## 88 Cambridgepark Drive

Submittal for Planning Board Review

The McKinnon Company *on behalf of* BRE/CPD, LLC // Cambridge, MA // 12 August 2014

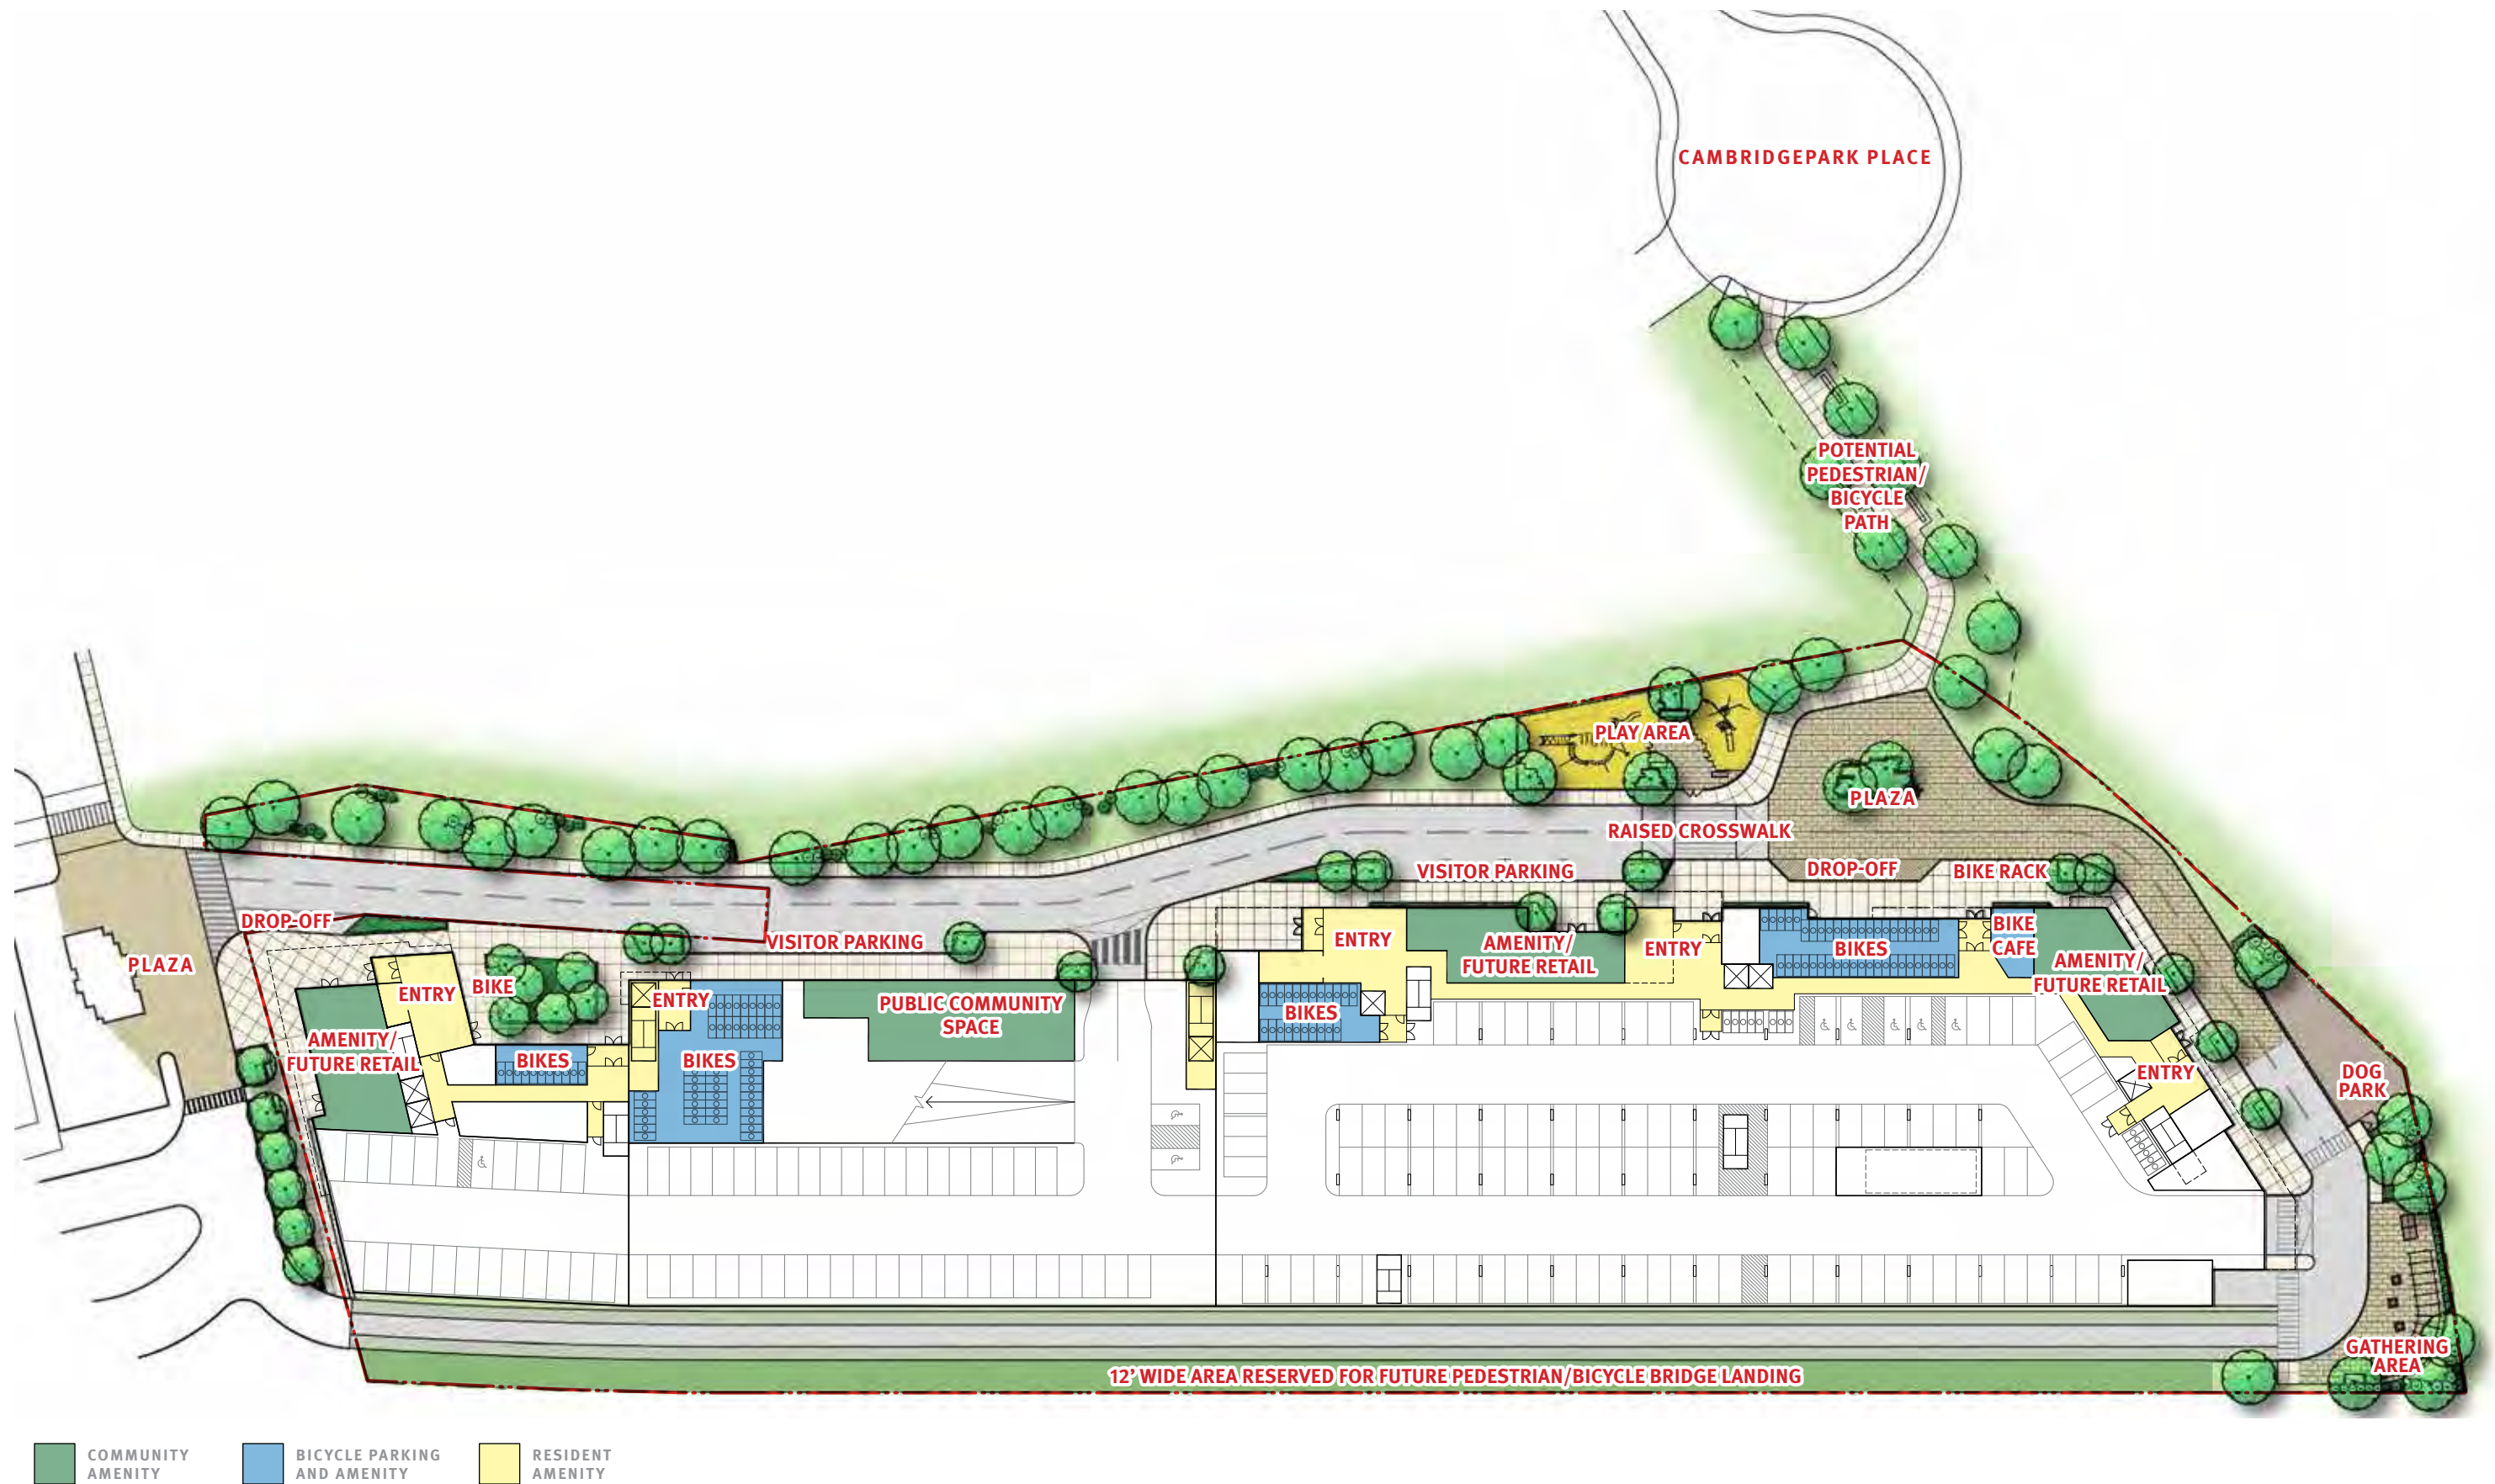
14. FIND OPPORTUNITIES TO CREATE MORE OPEN SPACE AT GROUND LEVEL; PROVIDE CLEAR CALCULATIONS OF AMOUNTS REQUIRED AND PROVIDED, AND;

The amount of open space, including permeable open space and publicly beneficial open space has increased. For example, permeable open space is 27.6%. The total of permeable and publicly beneficial open space is now at 34.7%. The footprint of the building has been reduced from +/- 98,300 to 91,800 sf. This is a reduction of 6,500 SF.

OPEN SPACE KEY 180R CPD:		OPEN SPACE CALCULATIONS:			
PERMEABLE ASPHALT/UNIT PAVERS (18,120 SF)			EXISTING	PROPOSED	% OF TOTAL LOT AREA
UNIT PAVERS (2,600 SF)		TOTAL PERMEABLE OPEN SPACE	29,161 S.F.	48,220 S.F.	27.6%
		TOTAL OPEN SPACE	NA	60,570 S.F.	34.7%
LOT AREA = 174,496 S.F.					
REQUIRED PERMEABLE OPEN SPACE: 25% OF 174,496 S.F. = 43,624 S.F. (MAY BE REDUCED TO 15% WITH LETTER FROM CITY ENGINEER)					
REQUIRED TOTAL OPEN SPACE: 15% OF 174,496 S.F. = 26,200 S.F.

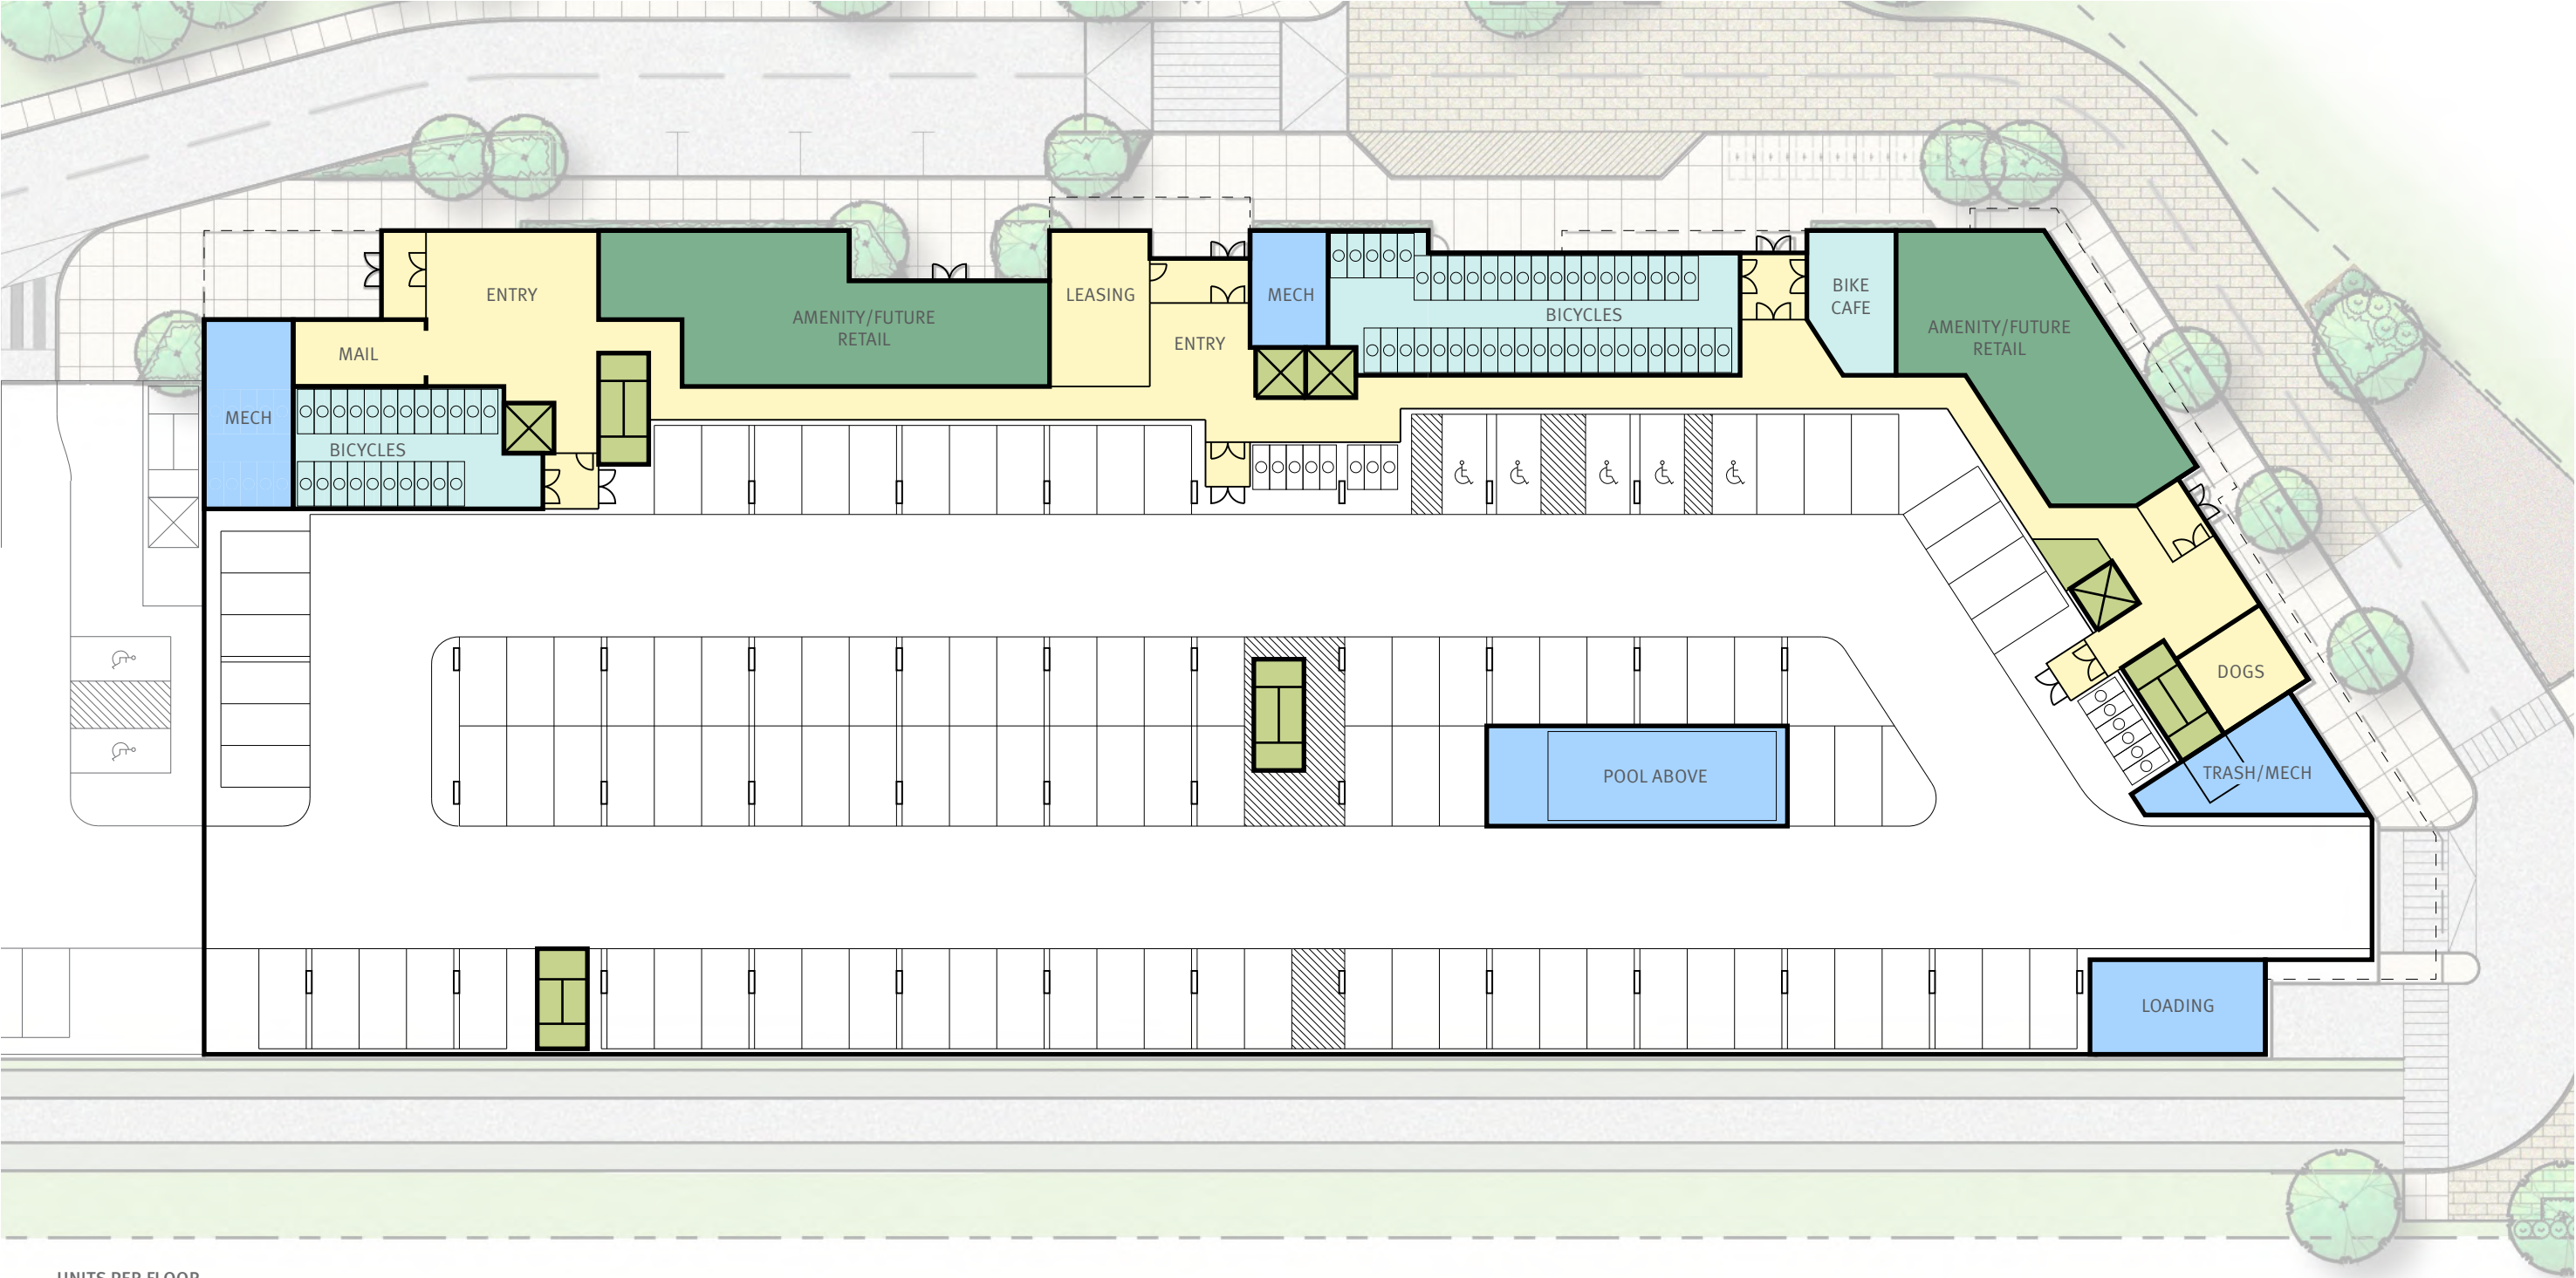
6. PROVIDE A CHART WITH UNIT SIZE BREAKDOWN; PROJECT NUMBER OF CHILDREN WHO MIGHT BE RESIDENTS

See chart on Sheet 15 for unit size breakdown. While we found no data to help us predict reliably how many children on average will live at 88CPD, the best indicator might be the information which Equity Residential recently provided to the applicant regarding the number of children at 30 CambridgePark Drive. Extrapolating from the experience at 30 CambridgePark Drive and making some adjustment for the differences in the unit mix, the expectation at this time is that approximately 30 children ages 0-5 and 10 children of school age will reside at 88 CambridgePark Drive.
